Docket Item #9
BAR CASE #2004-0068

BAR Meeting
August 18, 2004

ISSUE: Alterations and addition
APPLICANT: Steve Edson and Kelly Worthington
LOCATION: 510 North Columbus Street
ZONE: RM/Residential

The applicant is requesting approval of a Certificate of Appropriateness for alterations and an addition to the brick residential rowhouse at 510 North Columbus Street.

Figure 2 - Proposed Front Elevation

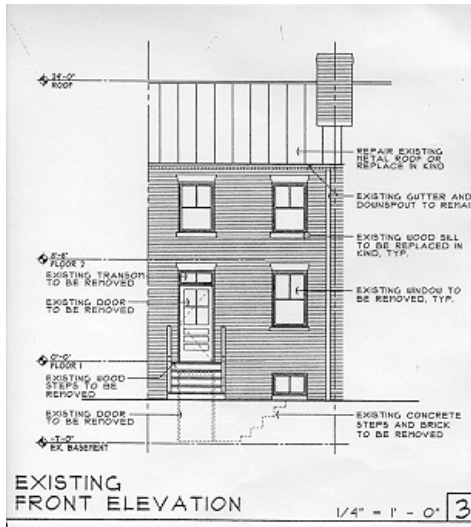
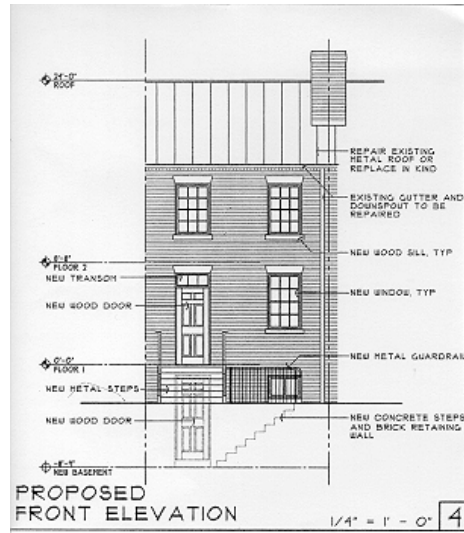
Staff has no objections to the alterations proposed for the front facade. With some clarifications, Staff believes the alterations are appropriate and will improve the historic appearance of the house. Staff can support simulated divided lights in this instance only because the new windows will be replacing the existing inappropriate non-historic windows and will not be readily accessible to the public as the house is set back from the sidewalk by over 8'. The manufacturer's cut sheets provided by the applicant were not entirely clear as which of the divided light options would be used. It is assumed that the windows will be wood with fixed wood muntin bars on the exterior and interior *and an internal spacer bar*. In addition, the rear elevation drawing in the current set includes a note calling for the removal of the existing chimney. It is assumed that this is an error. The applicant had previously proposed removing the chimney, which is original and shared with the neighboring house, but was dissuaded by Staff. Lastly, at the July 21, 2004 hearing, Board members noted that the metal roof on the row is continuous and requested that the existing roof be retained if at all possible. The applicant now proposes to "repair existing metal roof or replace in-kind." Obviously, if replacement is necessary, great care will be required to match the appearance of the existing row as closely as possible.

1. That the front windows be wood without cladding and be either true divided light or simulated divided light with internal spacer bars;
2. That if the metal roof is replaced, it match the existing and adjacent roofs as closely as possible;
3. That the existing chimneys be retained;
4. That the fiber cement siding is smooth and the nails do not show in the installation; and,
5. That the following statement appears in the General Notes of the site plan so that on-site contractors are aware of the requirement:

Figure 3 - Proposed Addition Rear Elevation

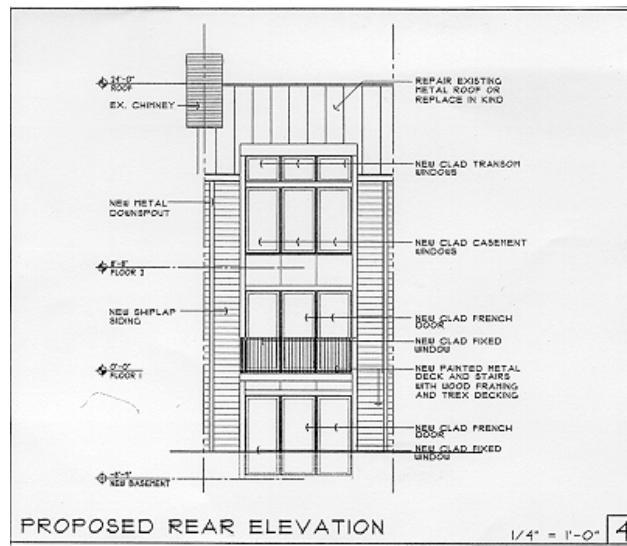
In general, Staff is supportive of a rear addition to this rowhouse and believes that the design vocabulary of the rear elevation is appropriate because the front facade and the rear elevation cannot be seen together. The design of the addition is clearly differentiated from the historic main block of the house, an approach recommended by the *Design Guidelines* (Residential Additions - Page 5). Moreover, Staff believes the revised design is an improvement over the previous in a number of ways. The revisions have reduced the perceived mass of the addition somewhat. The height of the main block of the addition has been reduced so that it no longer extends onto the roof of the historic house. The pop-up projecting bay section of the addition provides some modulation to the rear (west) elevation and adds interest to the north and south side elevations as well. In addition, portions of the rear wall of the existing main block will now remain intact, although encapsulated by the new addition and thus not visible.

Despite these improvements, Staff remains troubled by the overall size of the addition. As currently proposed, the addition represents an increase in the size of the existing house of nearly 77%. In the opinion of Staff, the addition is so large that it overwhelms the existing relatively small historic house. Although the projecting and fenestrated bay does provide some visual relief for the side elevations somewhat, the side walls remain as before, 21'6" in overall length and three stories high, overwhelming the adjacent houses which have no additions. The *Design Guidelines* note that "[g]enerally, additions should not overwhelm the existing structure or neighboring buildings" (Residential Additions - Page 6). There are several additions in the row of eight that are of similar or even greater length. However, all were approved over a decade ago. On a more practical note, Staff has concerns about the fact that the proposed addition leaves only 800 square feet of open space, exactly what is required by zoning. This leaves virtually no

margin for error in the construction process. Based upon all the above, Staff believes that the application should be deferred for restudy for an addition that is more appropriate to the size of the existing house and its immediate neighbors.

While the Board generally prefers wood windows, Staff does not object to the proposed use of Ultrex for the rear windows. These windows will be well removed from the public access and will be on a clearly modern structure. The Board has adopted the following policy with respect to fiber cement:

Staff recommends: deferral for restudy of the size of the proposed addition. In the alternative, if the Board determines to approve the addition, Staff recommends the following conditions:

Figure 4 - Proposed Addition North Elevation

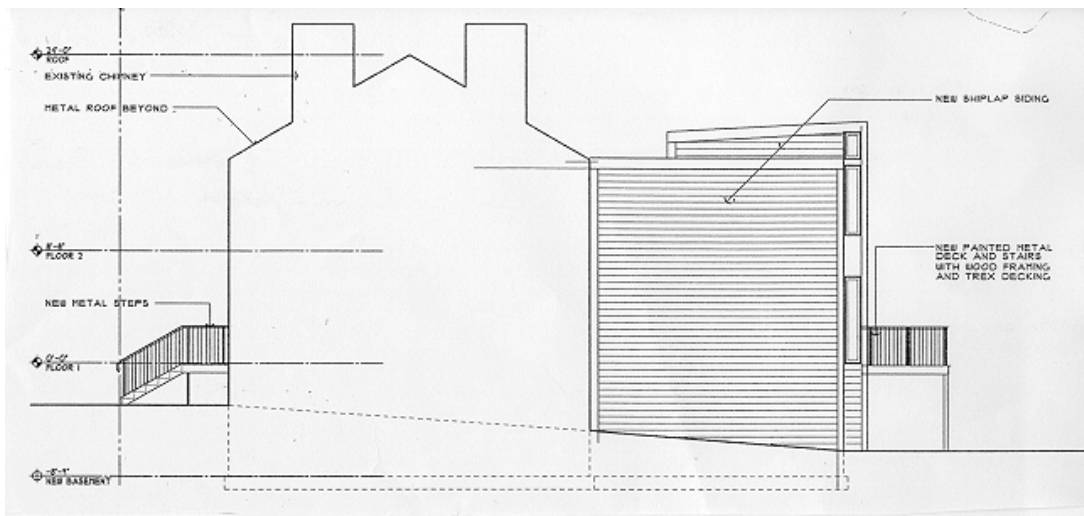
Although only the north elevation is shown, it is assumed that the north and south side elevations will be identical. They will be clad in fiber cement shiplap siding. The projecting bay will extend above and beyond the main block of the addition and will have narrow windows on the first and second stories.

As fiber cement siding is proposed only for the new construction, its use will conform to the Board's policy if the siding is smooth and the nails do not show in the installation.
